GNRO-2012/00001

January 23, 2012

SUBJECT: License Amendment Request - Standby Liquid Control System

Grand Gulf Nuclear Station, Unit 1
Docket No. 50-416
License No. NPF-29

~~FIGURE 3.1.7-1~~

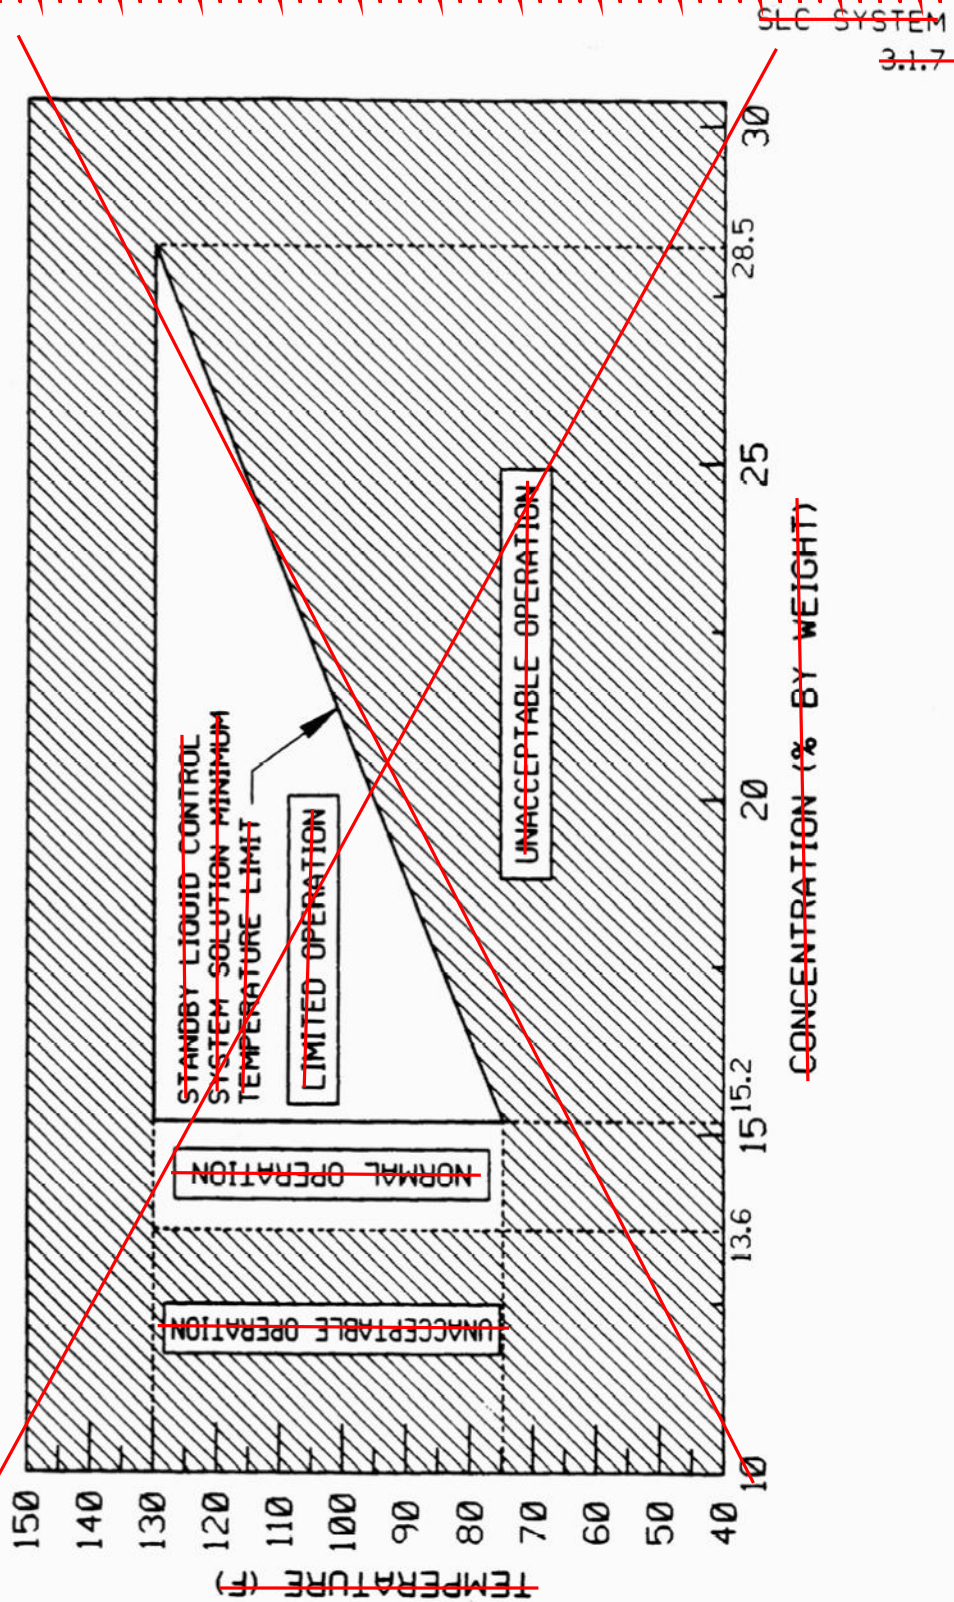
- SR 3.1.7.1 is being revised to verify the available volume of the SPB solution is greater than or equal to 4,200 gallons. This change eliminates the reference to Figure 3.1.7-1.

- SR 3.1.7.2 is being revised to verify the temperature of the SPB solution is greater than or equal to 45°F and less than or equal to 150°F. This change eliminates the reference to Figure 3.1.7-2.

With the proposed revisions described above, Figures 3.1.7-1 and 3.1.7-2 are no longer needed and are proposed for deletion. A note will be added to page 3.1-23 stating that the next page is 3.1-26. This is an administrative change that allows the current TS page numbering to remain the same.
